DESIGN DIVISION MARKUP PLANS COMMENTS

CC4 STABILTY BUTTRESS PROJECT

ENCLOSURE 2
BUILDING AND SAFETY DIVISION MARKUP
PLANS COMMENTS
CC4 STABILITY BUTTRESS PROJECT

We have reviewed the following documents submitted by Republic Services to Public Works on October 30, 2018, for the design change of CC-4 Stability Buttress Grading and Drainage project:

DOWNDRAIN AND ANCHOR
SECTION

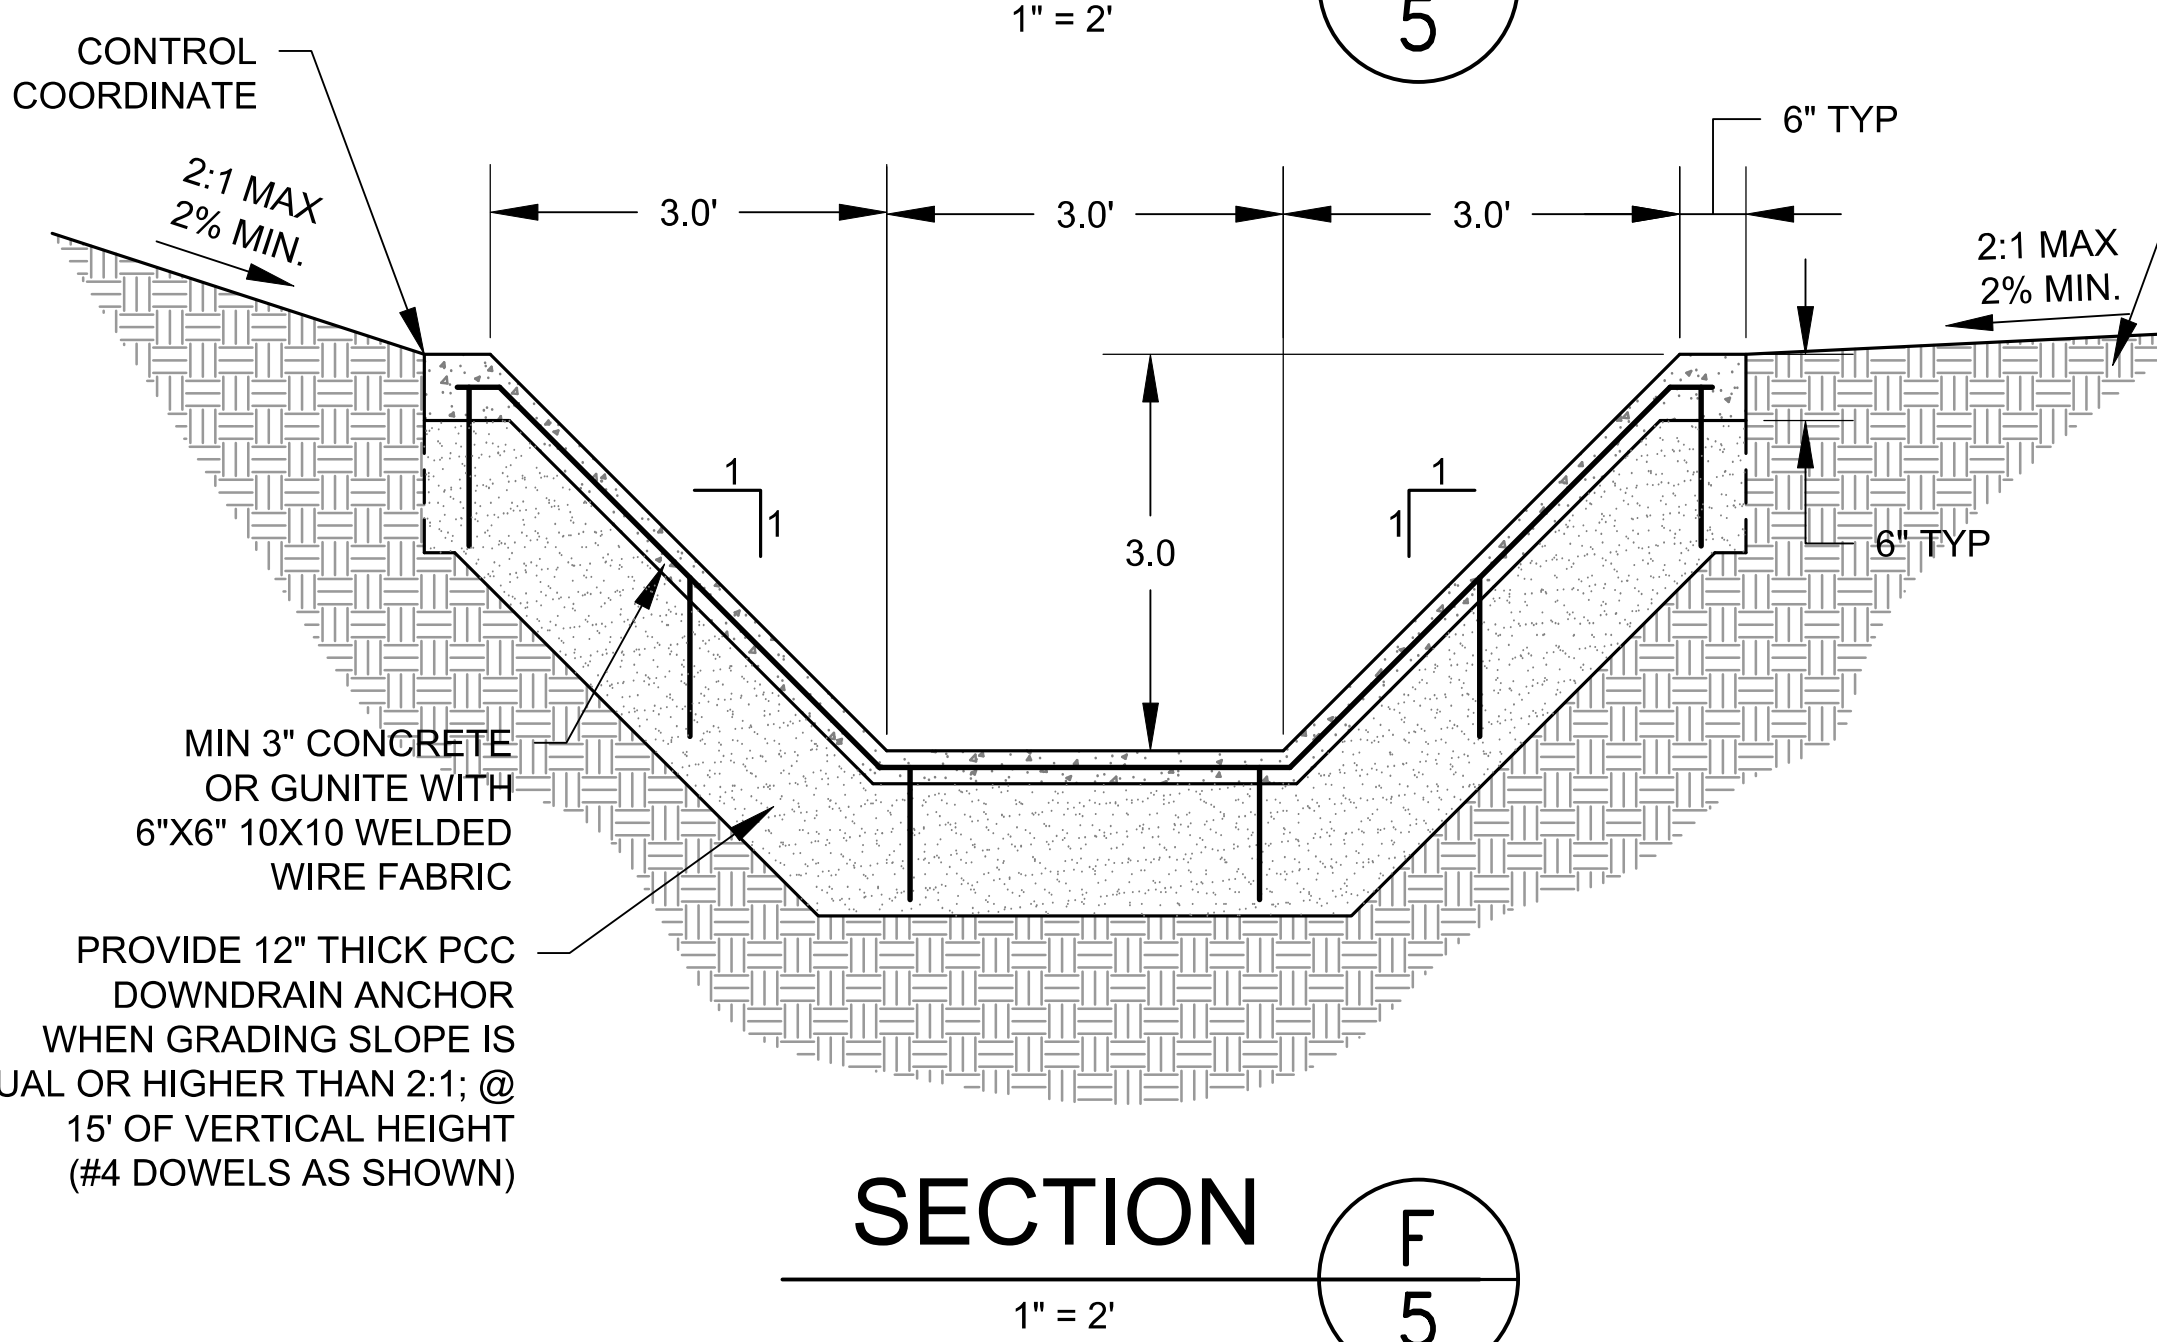
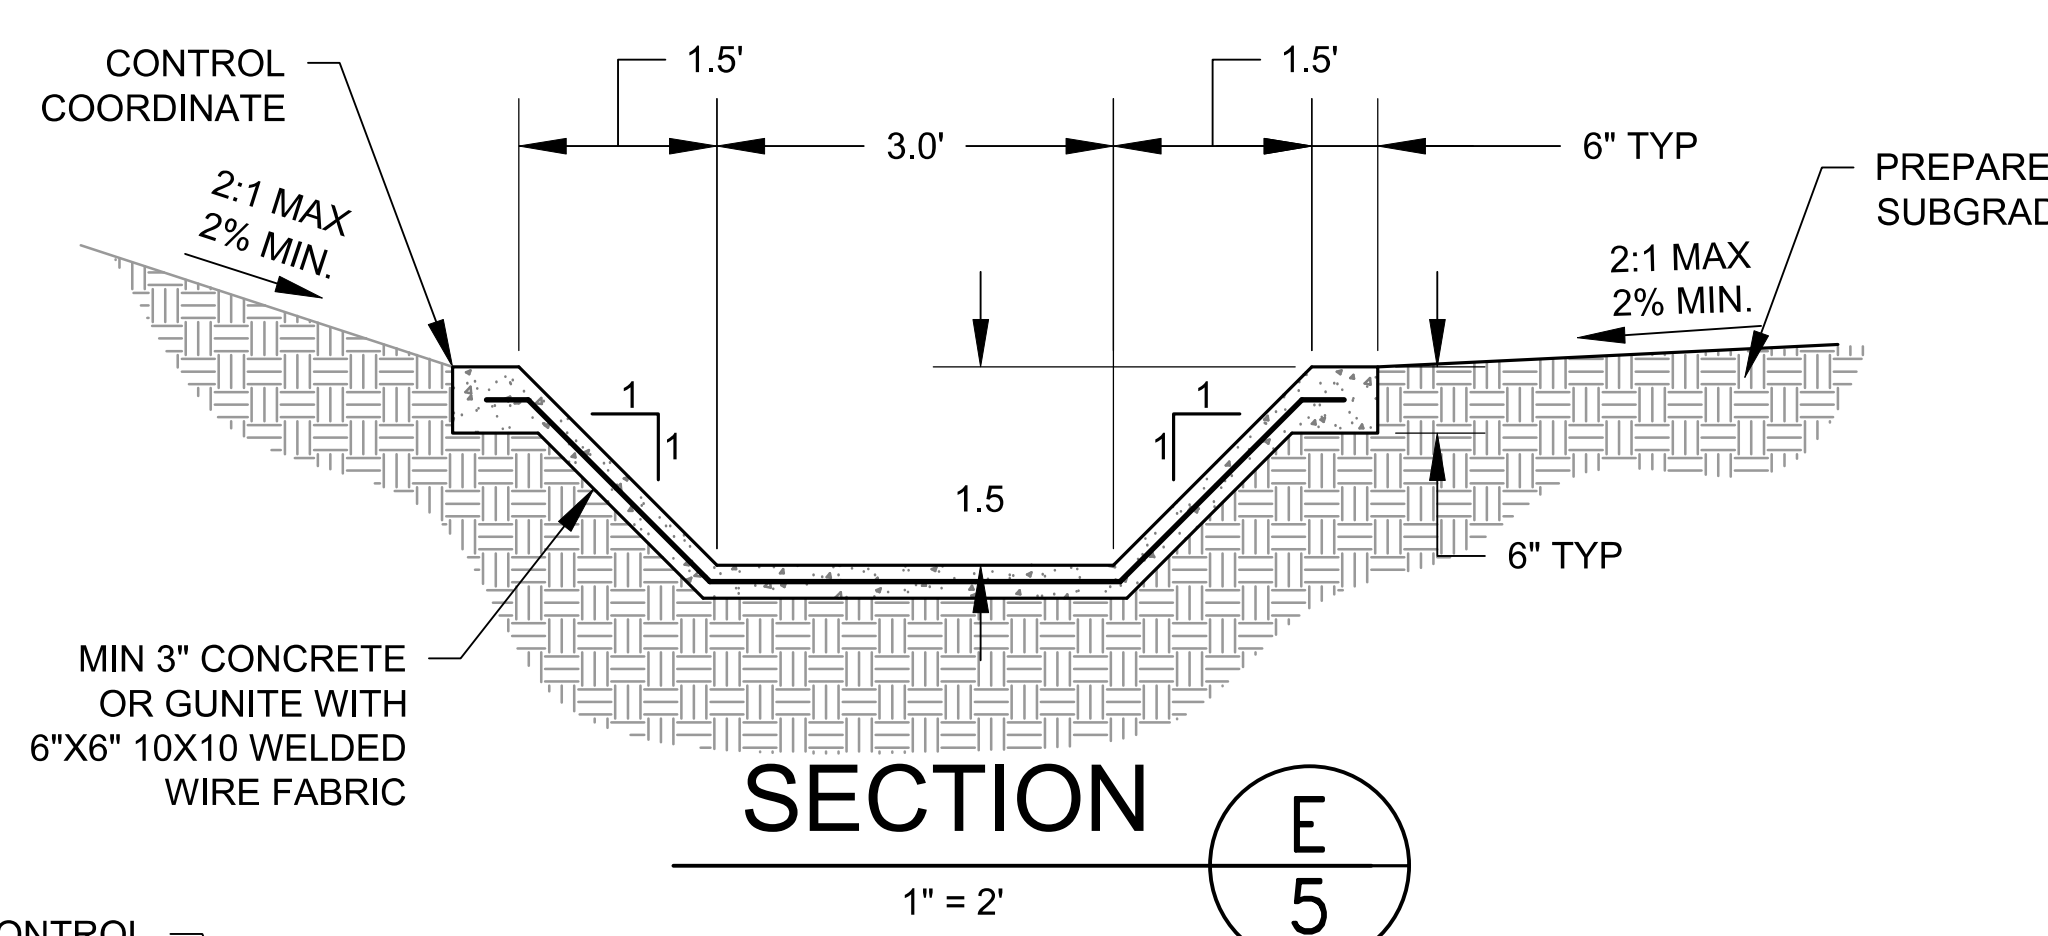
This section is no longer applicable

TITLE SHEET

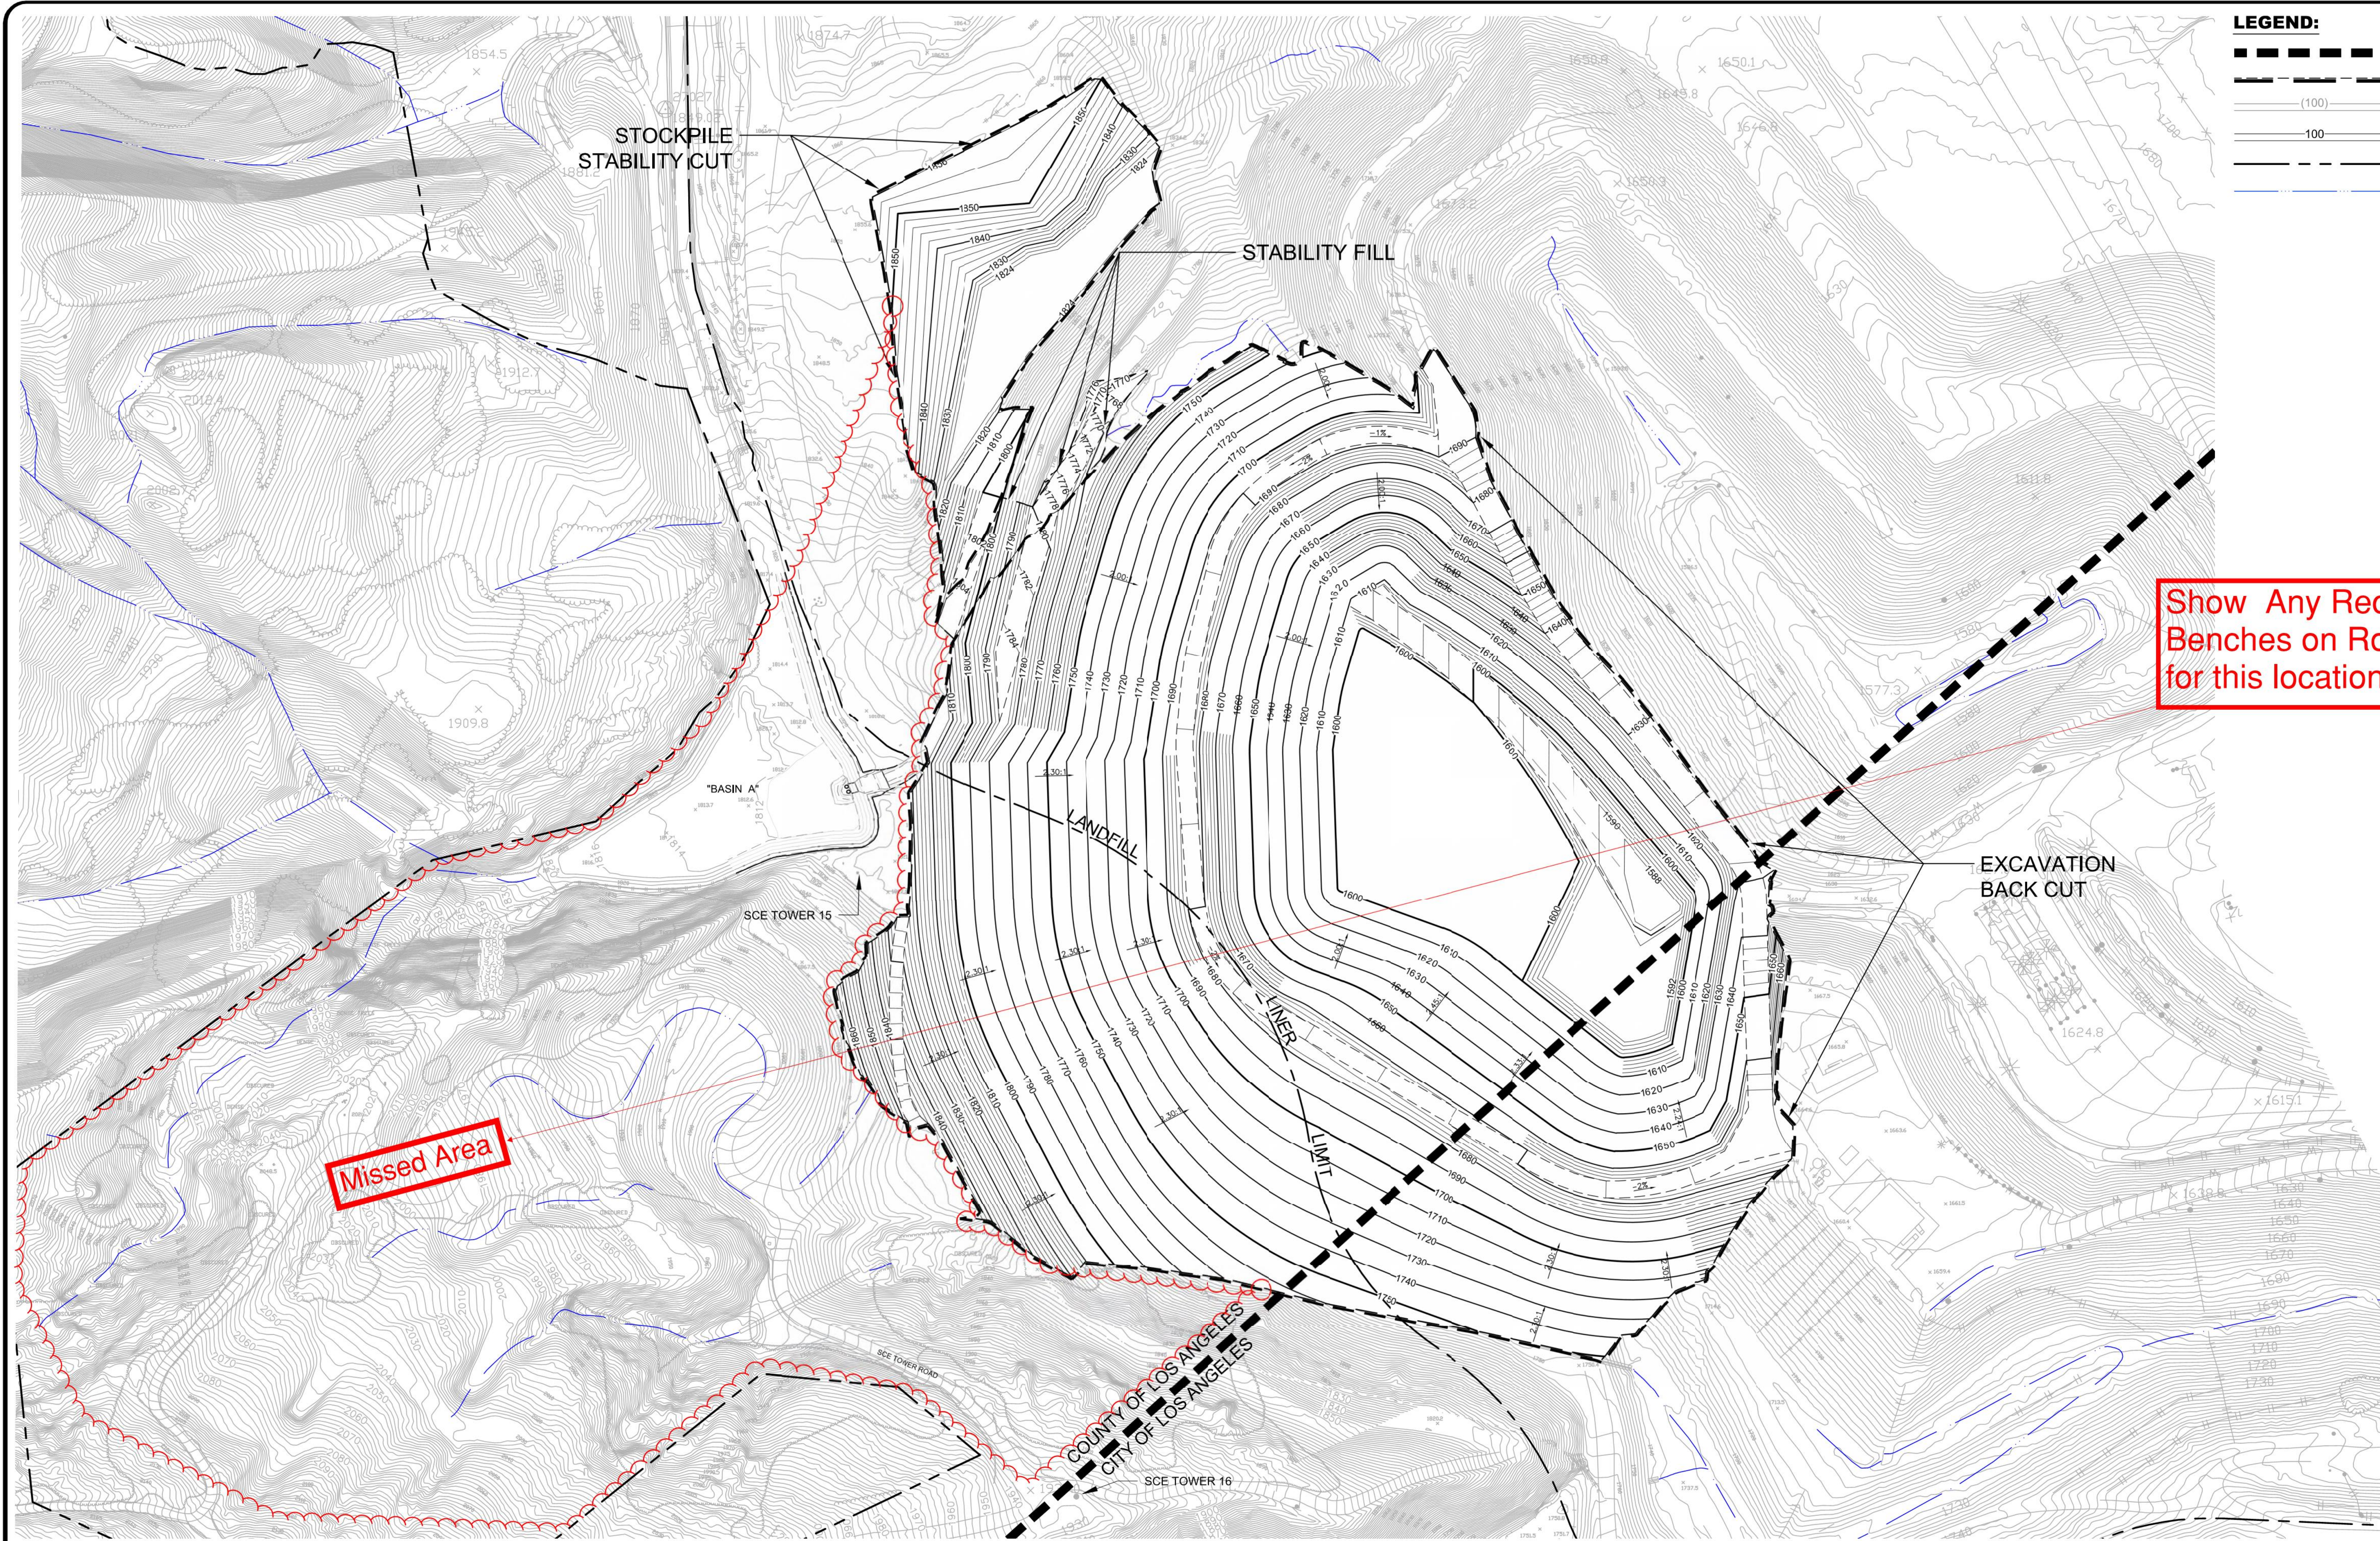
Verify/Revise
Earthwork
Quantities Based
On Plan Revisions
